**DRAINAGE STUDY
FOR
VISTA II BALLFIELDS
(PRELIMINARY ENGINEERING)**

Job Number 19253-B

This Drainage Study presents a revision to the October 16, 2023 report pursuant to the County of San Diego plan check comments received January 24, 2024. The following text identifies the plan check comments along with the responses in bold.

HEC-RAS CROSS SECTIONS AND WATER SURFACE ELEVATIONS

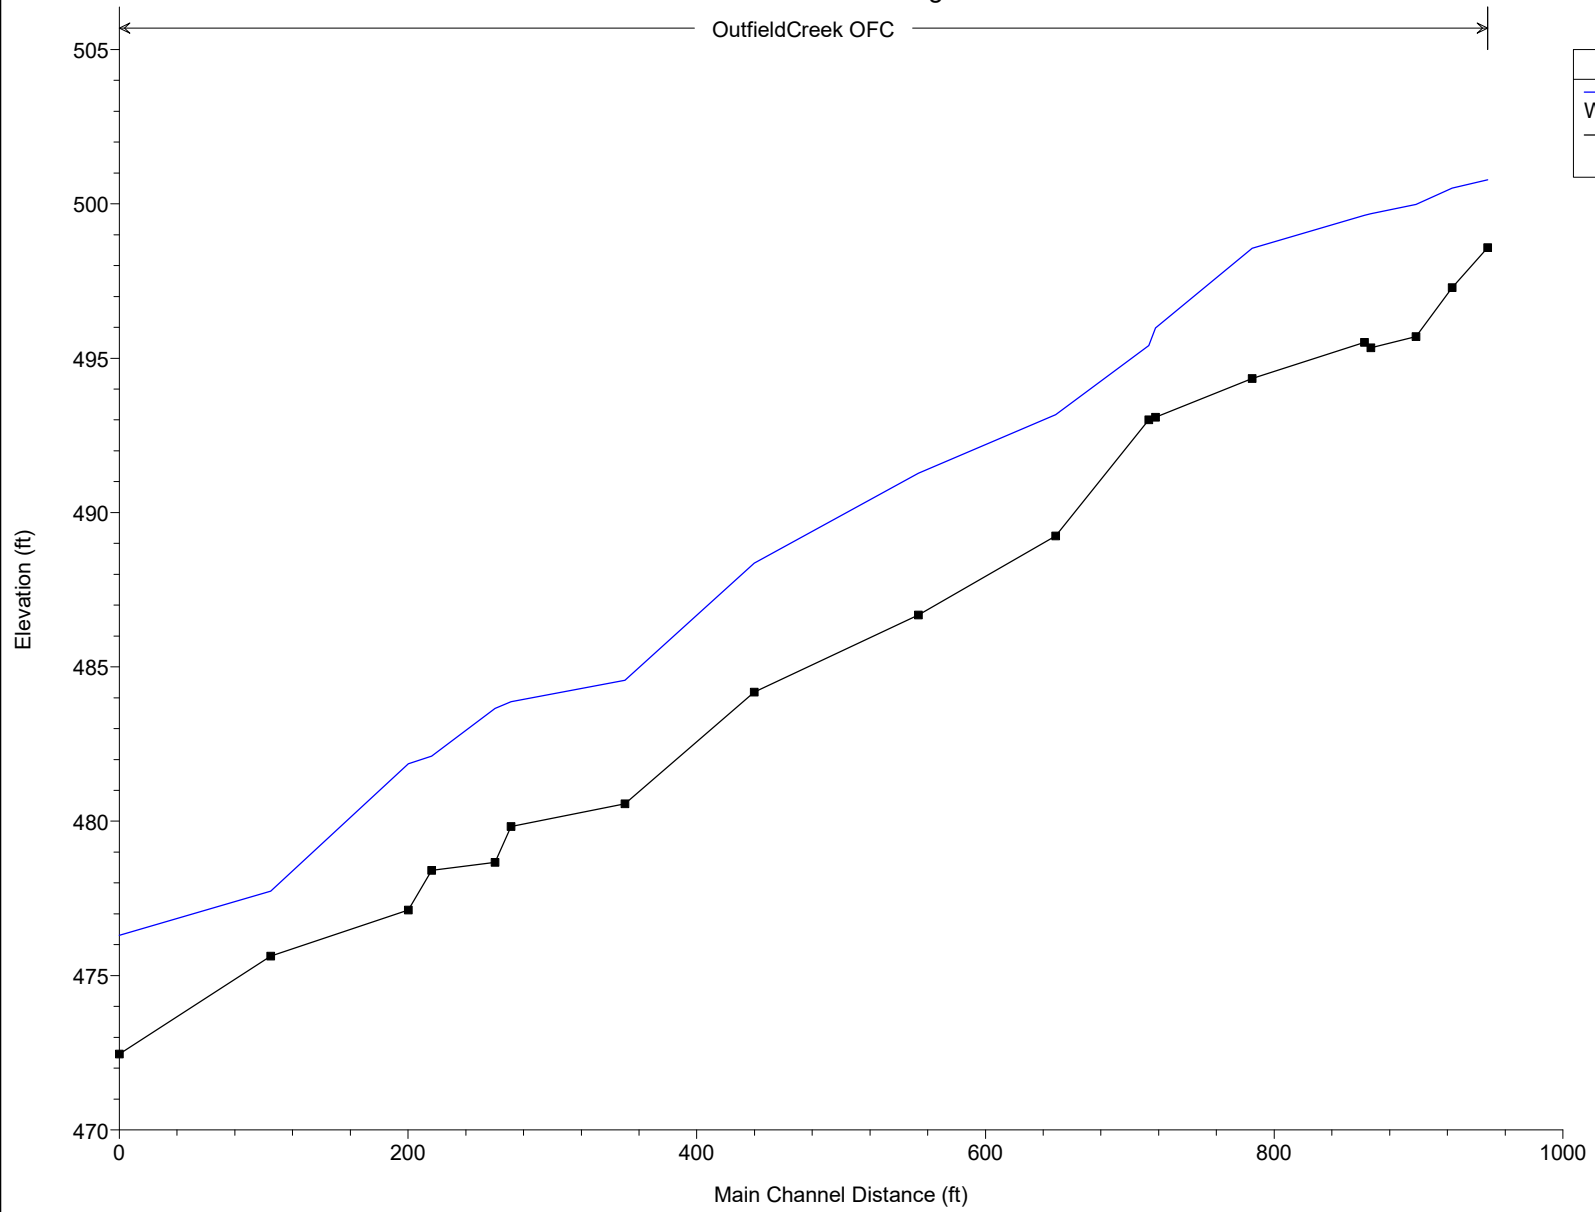
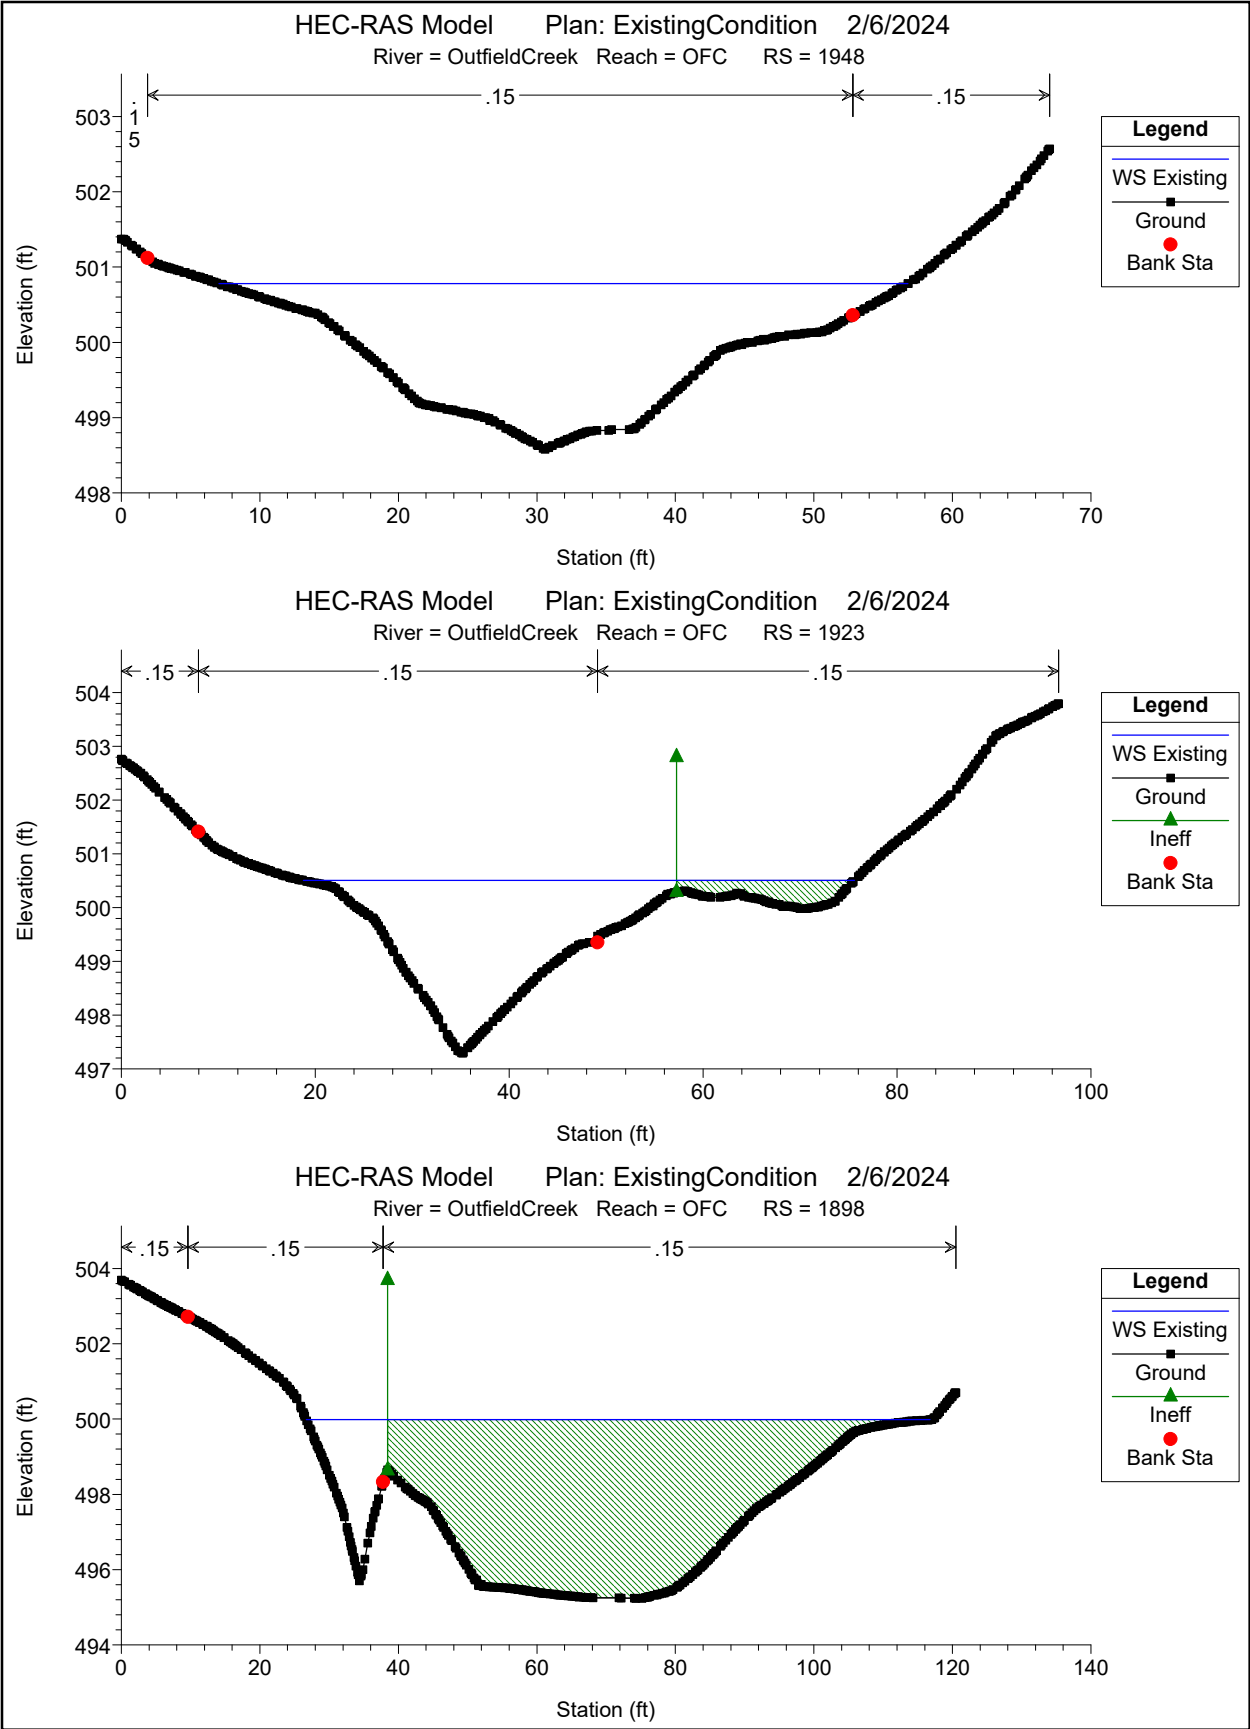
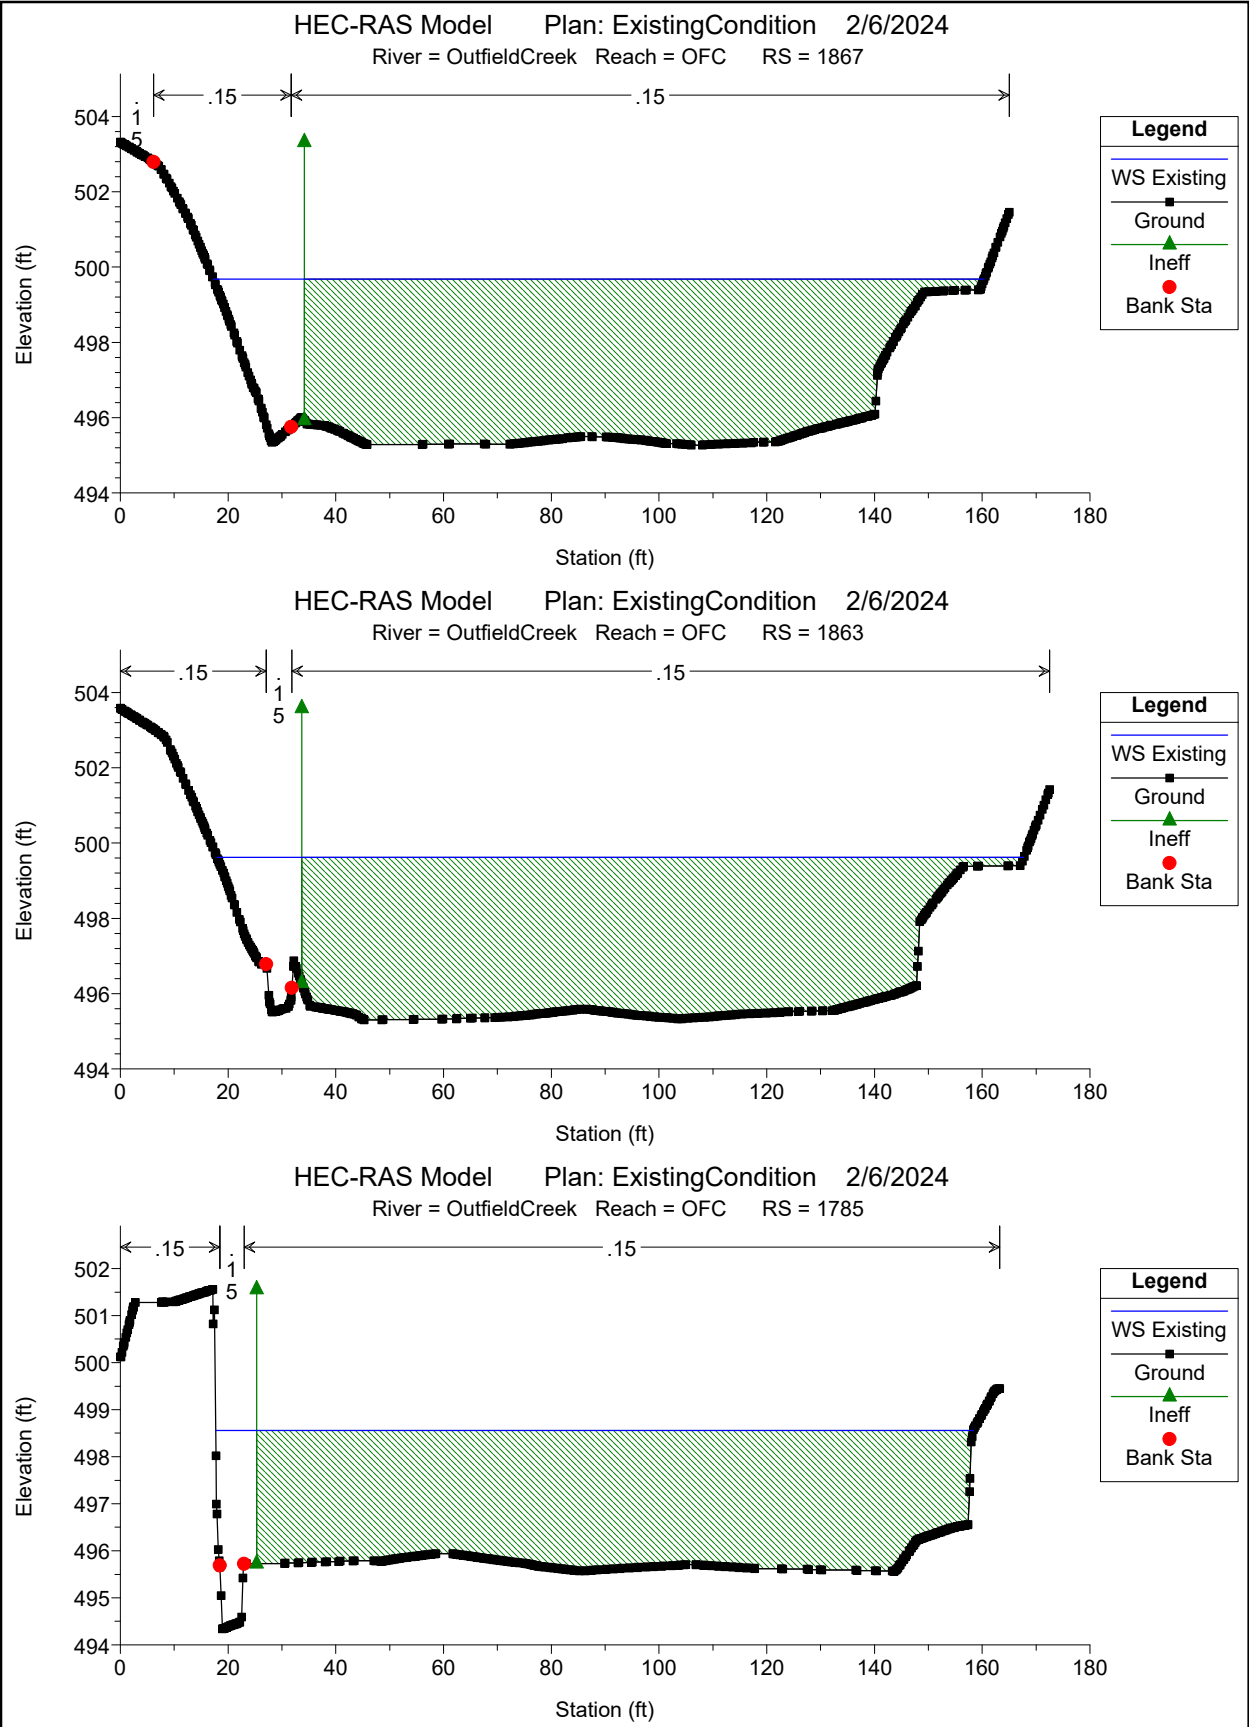
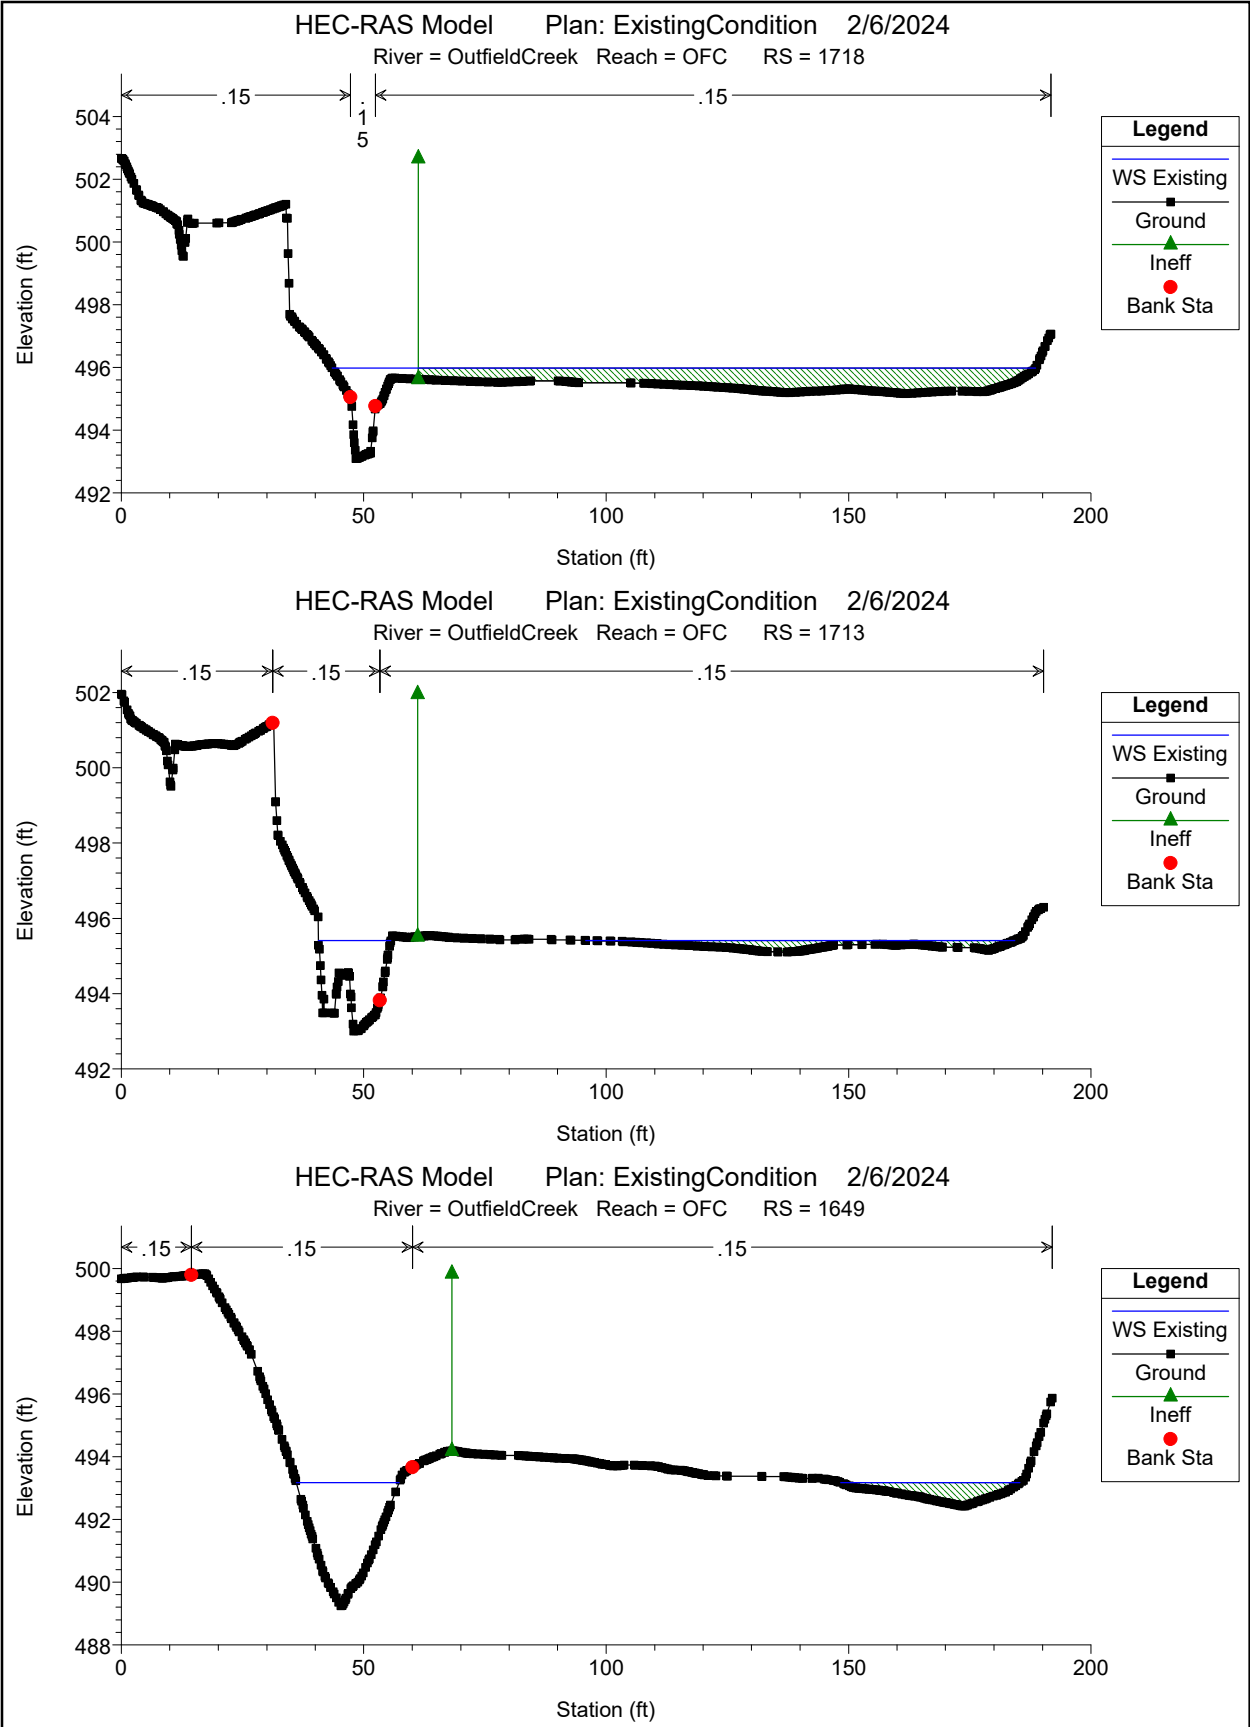
Based on a call with the County of San Diego on April 11th, 2024, it was requested to show the lot lines for the proposed project on the Hydraulic workmap to show in the limited locations where we see an increase in water surface elevation that it is contained within the proposed project's property limits. Additionally, a note has been added to the exhibit to acknowledge that for one upstream cross-section (1899) that extends beyond the property limits only a 0.01-ft increase is recorded which, considering the limits of the model, effectively rounds to 0.0-ft. The table shows results to two decimal points to be consistent with the HEC-RAS model output.

7-33b. 3rd Review Comment: The values for the water surface elevation appear to indicate an increase at certain stations. Due to increase in water surface elevation for the existing channel, document if the increase is contained on the project's private property or if the increase will impact existing neighboring property owners.

Response: The water surface elevations and HEC-RAS model has been revised. Any increase to WSEL is contained within the project's private property.

1. THERE IS AN INCREASE IN WATER SURFACE ELEVATION AT CROSS-SECTION 1105. HOWEVER, THIS INCREASE IS WITHIN THE LIMITS OF THE PROJECT AND DOES NOT EFFECT OTHER PROPERTIES. OTHER CROSS-SECTIONS AT THE UPSTREAM END OF THE PROJECT (1899, 1868, 1863, AND 1758) SHOW AN INCREASE OF LESS THAN 0.05-FT. WHICH GIVEN THE LIMITATION OF THE MODELING SOFTWARE, SHOULD EFFECTIVELY ROUND TO 0.0-FT. THE TABLE HAS BEEN SHOWN TO TWO DECIMAL PLACES FOR CONSISTENCY WITH THE HEC-RAS OUTPUT.
